COLLIN COUNTY

ADDENDUM NO. One (1)

RFP No. 2017-169

DISPATCH CONSOLE FURNITURE

1 **NEW CCSO DISPATCH PLAN**
1/8" = 1'-0"

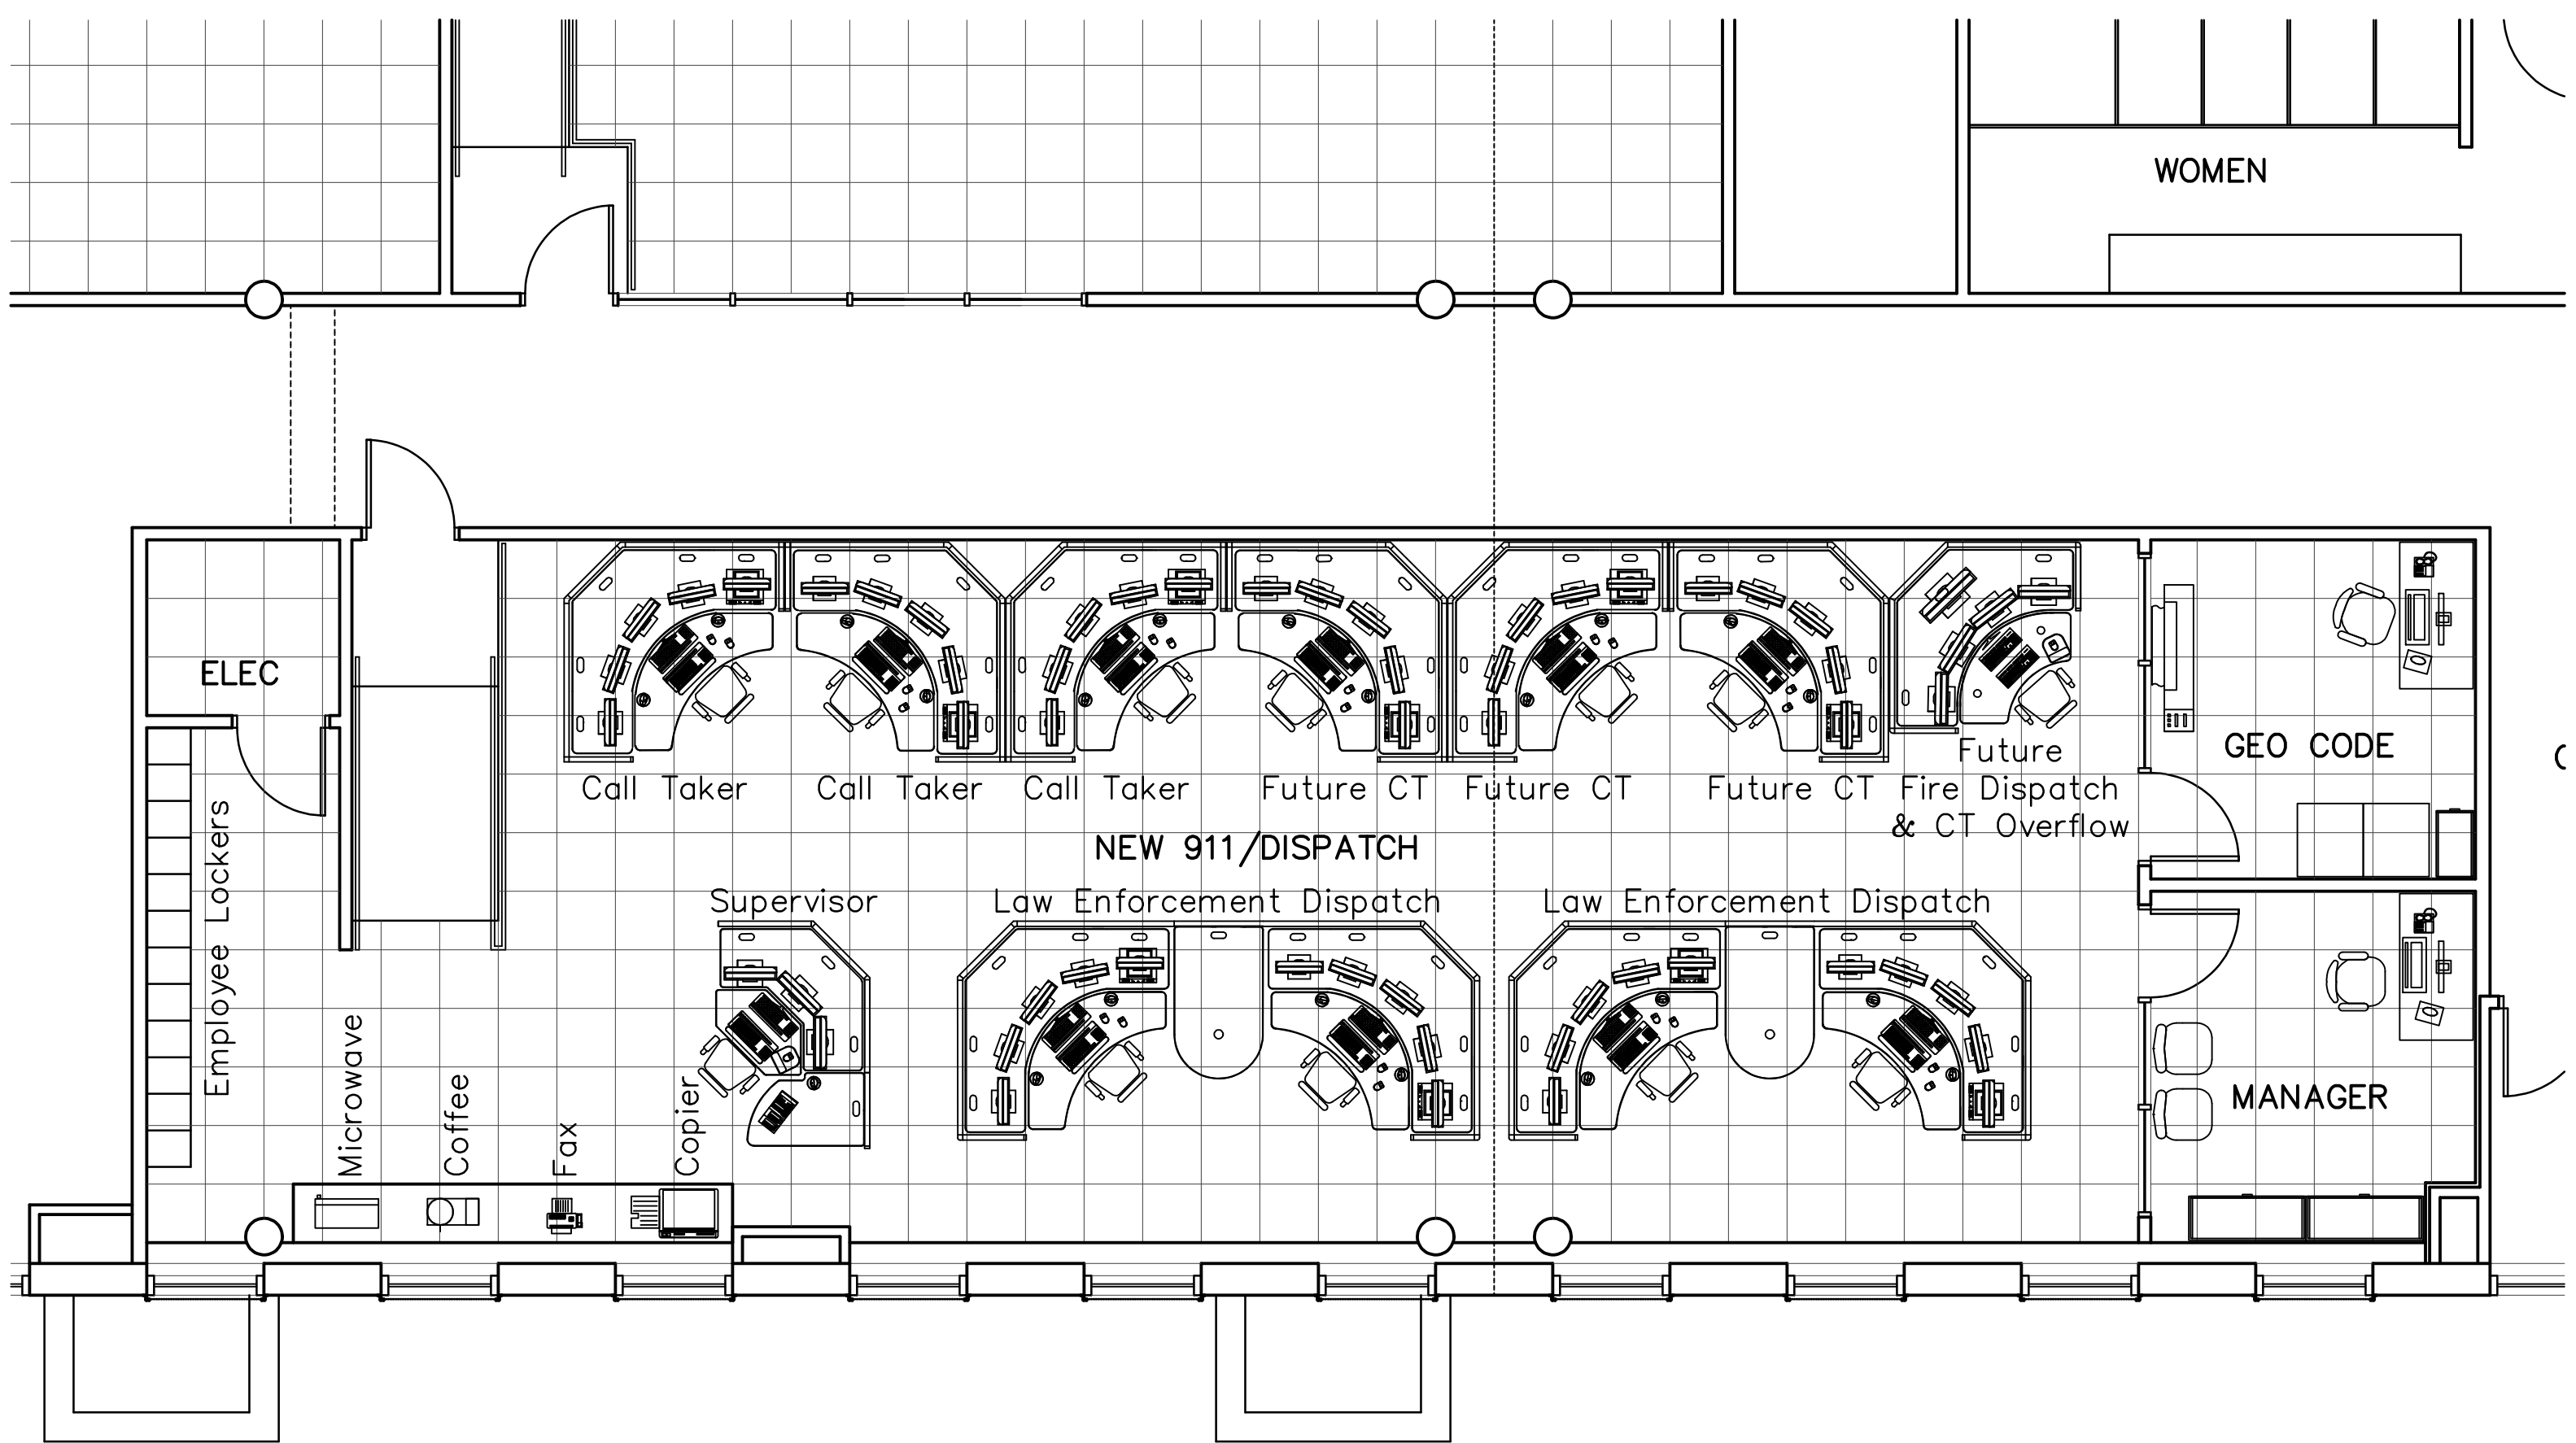
Please refer to the revised drawing. Collin County is now requiring that the size configuration of the 3 Call Taker positions be increased to match the size configuration of the 4 Radio Dispatch Positions.

Removed Design Drawing. See Attachment A for new Drawing.
